## REFL165 modification by KA Oct. 17, 2011 updated Feb 28 2012

Title <b>LSC Photodiode</b>		Date Last Modified: 17-May-99	
Size: B	DCC Number: D980454-01-C	PCB / SCH Revision: B / 1	Engineer: J. Suima D. Ouimette
File: S:\SYSTEMS\LSCPHOTOD-1\FINAL\SCHEMA-1\8045401A.SCH		Date: 12-Aug-1999	Time: 16:56:25
		Sheet 2 of 2

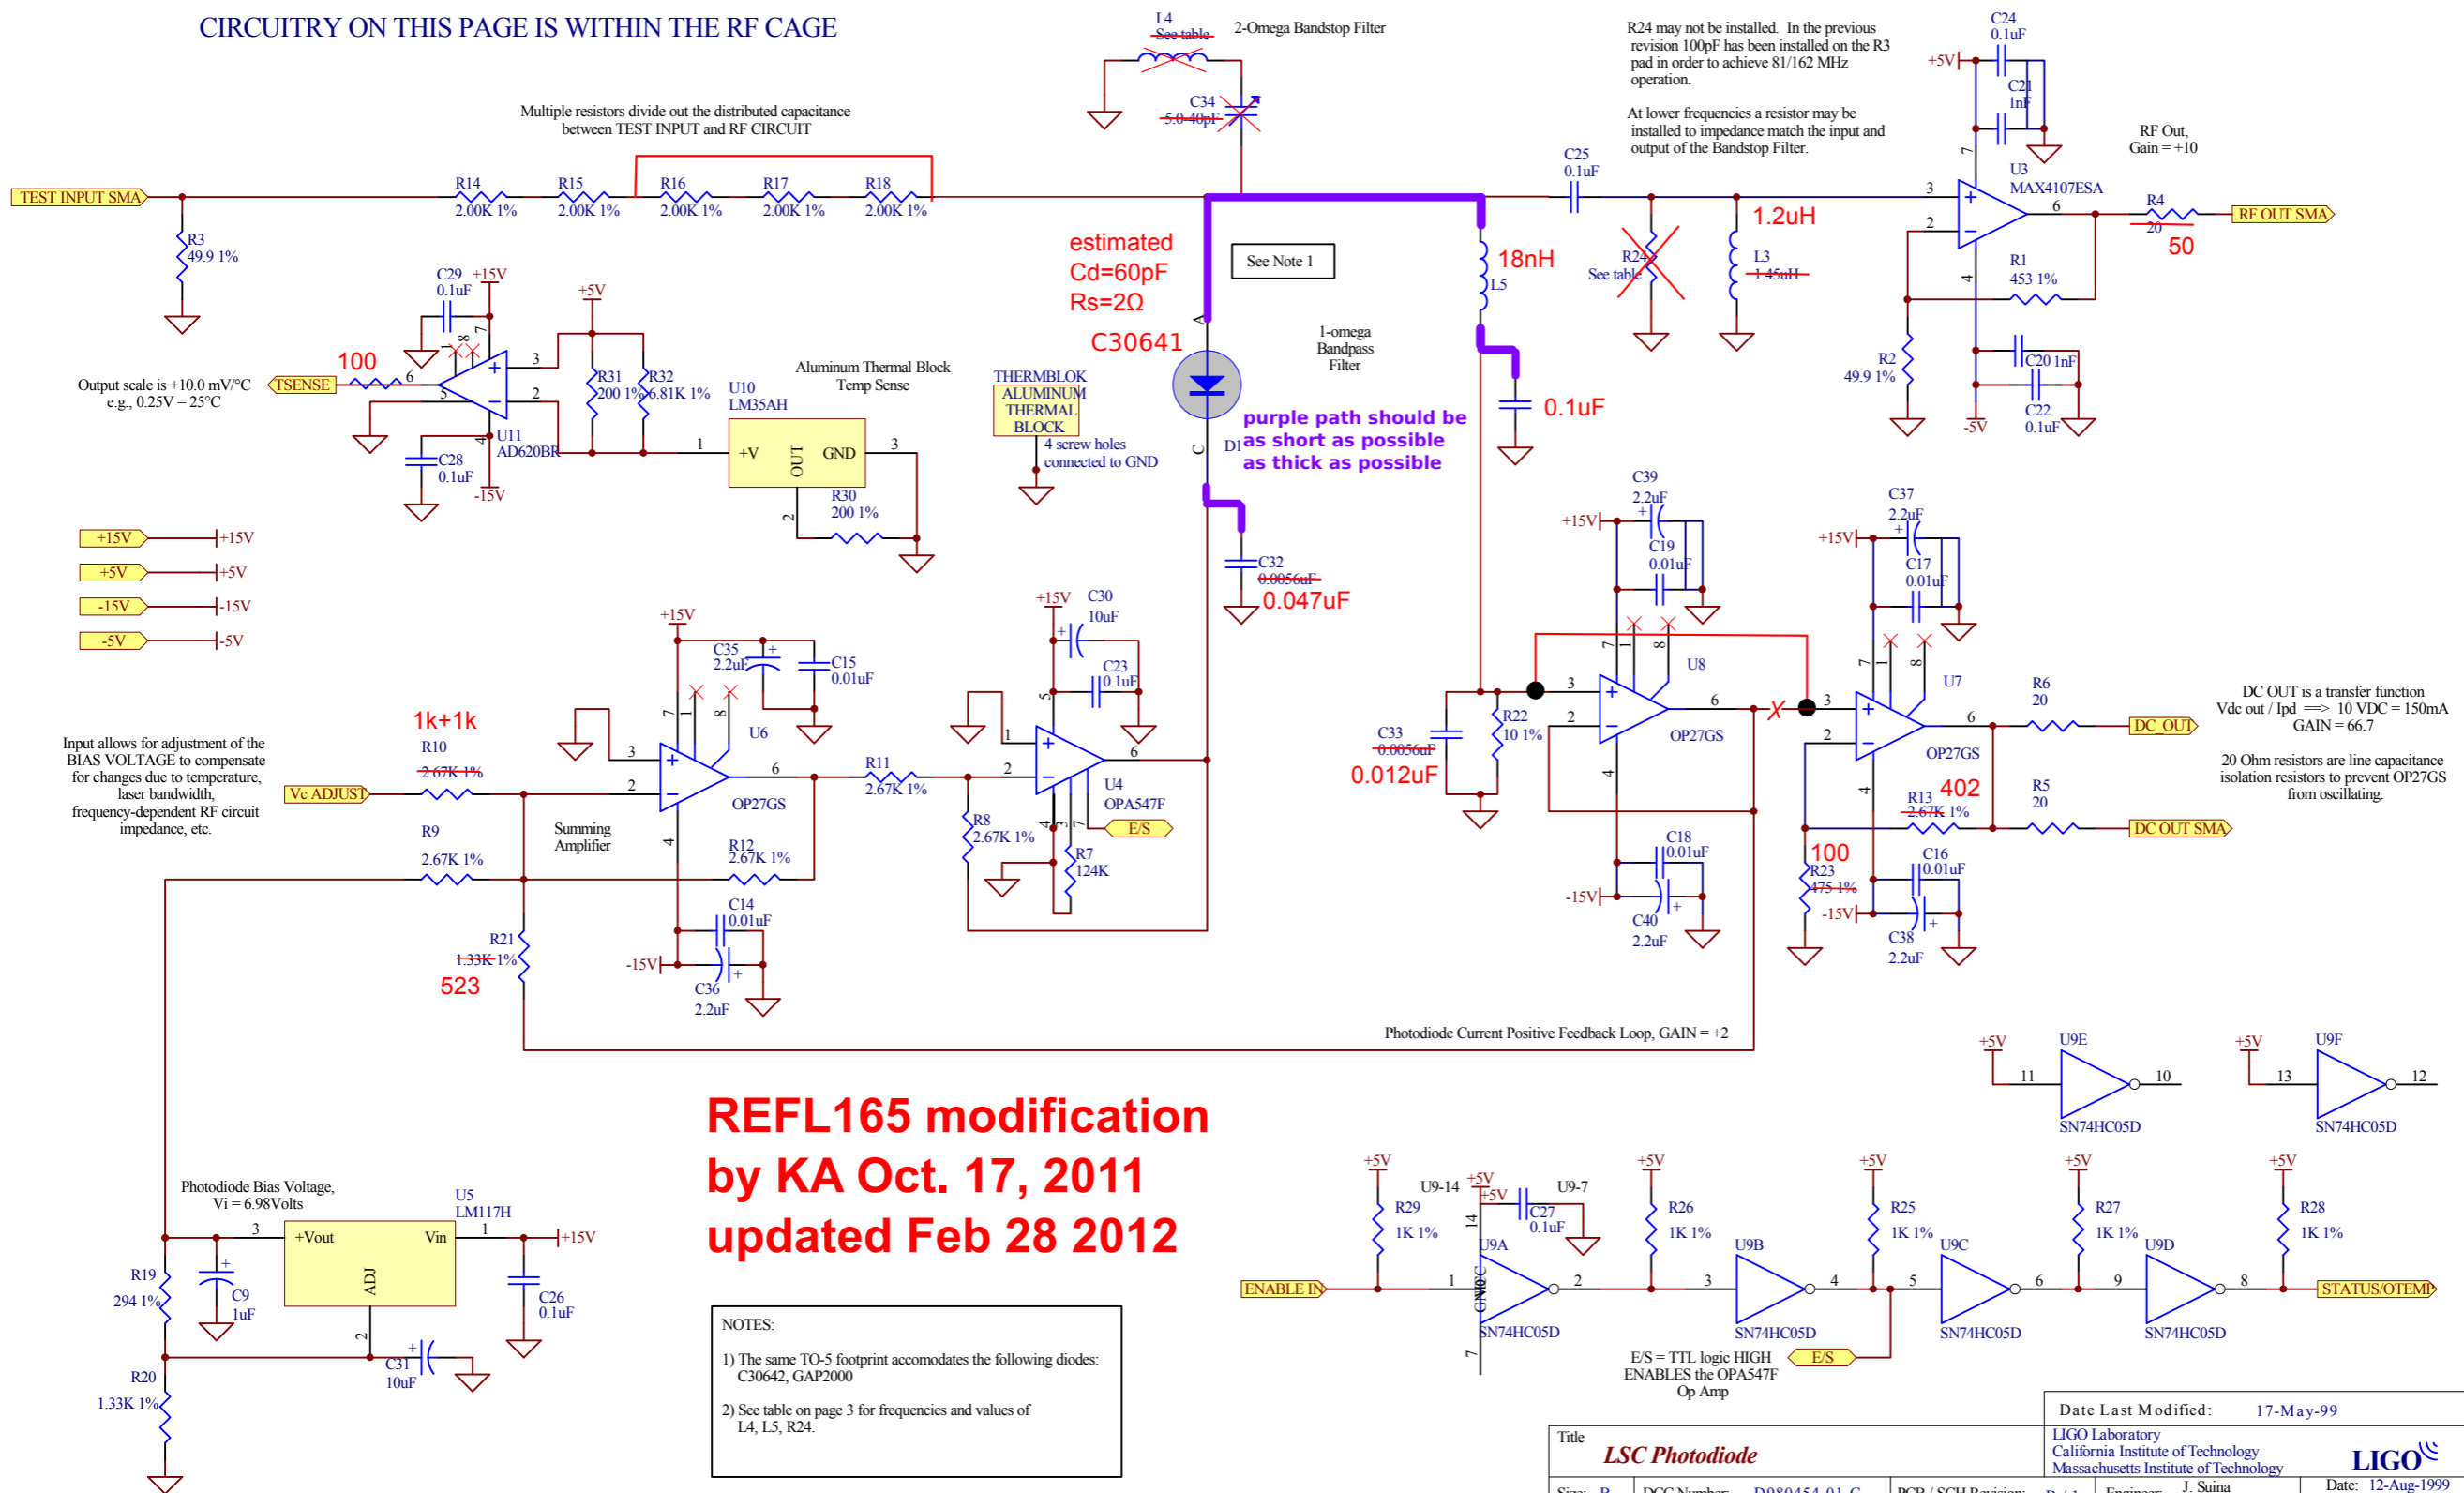
purple path should be as short as possible as thick as possible

R24 may not be installed. In the previous revision 100pF has been installed on the R3 pad in order to achieve 81/162 MHz operation.  
At lower frequencies a resistor may be installed to impedance match the input and output of the Bandstop Filter.

DC OUT is a transfer function  
Vdc out / Ipd => 10 VDC = 150mA  
GAIN = 66.7  
20 Ohm resistors are line capacitance isolation resistors to prevent OP27GS from oscillating.
